**URGENT - Field Safety Notice  
Medical Device Correction**

Continuous CT Fluoroscopy DVI Ceiling Mount – CCT Arm DVI Option - Monitor Bracket Assembly  
Significant Wear of CCT Fluoroscopy Monitor Bracket Mounted into the Suspension Arm

FSN 72800751 Revision: A

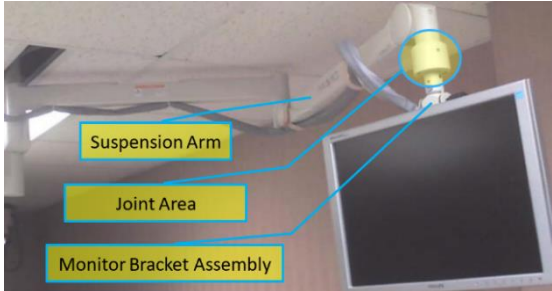
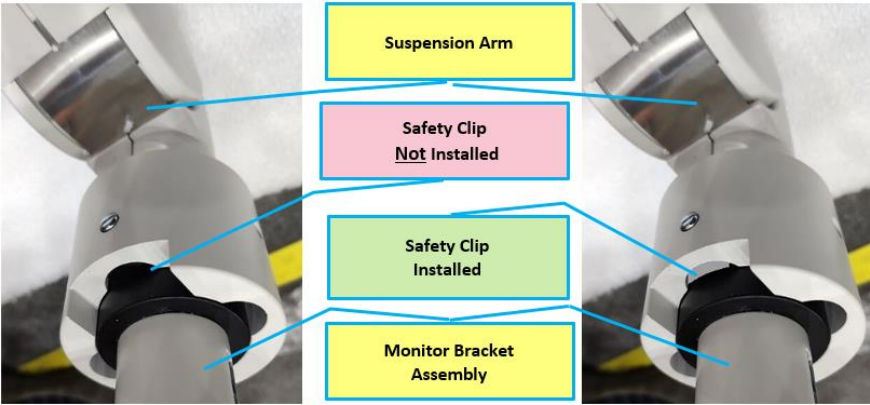
<b>AFFECTED PRODUCTS</b>	Philips Monitor Bracket Assemblies mounted into the Continuous CT (CCT) Digital Visual Interface (DVI) Ceiling Mount Arm Option for select CT products.
<b>PROBLEM DESCRIPTION</b>	Significant wear of the Monitor Bracket Assembly shaft that goes unrecognized could potentially lead to the Monitor Bracket Assembly detaching from the Suspension Arm.
<b>HAZARD INVOLVED</b>	If the Monitor Bracket Assembly were to detach from the Suspension Arm, there is a potential hazard for the monitor to fall while remaining attached to the cables. There is potential that a patient, operator, bystander, or service person located in the path of a falling part could sustain injury or may lead, in rare and specific circumstances, to serious injury or even death. There have been no reports of death or serious injury.
<b>HOW TO IDENTIFY AFFECTED PRODUCTS</b>	Philips has identified that your device may be affected by this issue.

<b>ACTION TO BE TAKEN BY CUSTOMER / USER</b>	<ul style="list-style-type: none"> <li>• Be aware of this hazard when the safety clip is missing from the joint assembly between the Monitor Bracket Assembly and the Ceiling Suspension Arm.</li> <li>• Inspect the joint area of your CCT DVI Ceiling Mount Arm (the circled area in picture at the right) and observe that the safety clip is installed (as depicted in pictures below).</li> <li>• When this hazard occurs, the monitor may become difficult to rotate relative to the Suspension Arm.</li> </ul>   <p style="text-align: center;"><i>(continued on next page)</i></p>

<b>ACTION TO BE TAKEN BY CUSTOMER / USER</b>	<p style="text-align: center;"><i>(continued from previous page)</i></p> <p>When these symptoms are recognized, in order to avoid the occurrence of a hazardous situation, take the following actions:</p> <ul style="list-style-type: none"><li>▪ stop using the suspension monitor clinically</li><li>▪ move the monitor arm away from any person</li><li>▪ call Philips Service for repairs.</li></ul> <p>Please acknowledge the receipt of this notice by completing, signing, and returning the form attached at the end of this communication to the indicated email address.</p>
<b>ACTIONS PLANNED BY PHILIPS</b>	Philips will inspect systems via Field Change Order FCO 72800751. Systems failing the inspection will be corrected via Field Change Order FCO 72800752.
<b>FURTHER INFORMATION AND SUPPORT</b>	If you need any further information or support concerning this issue, please contact your local Philips representative or the UK Philips Customer Care Service Centre on 0870 532 9741.
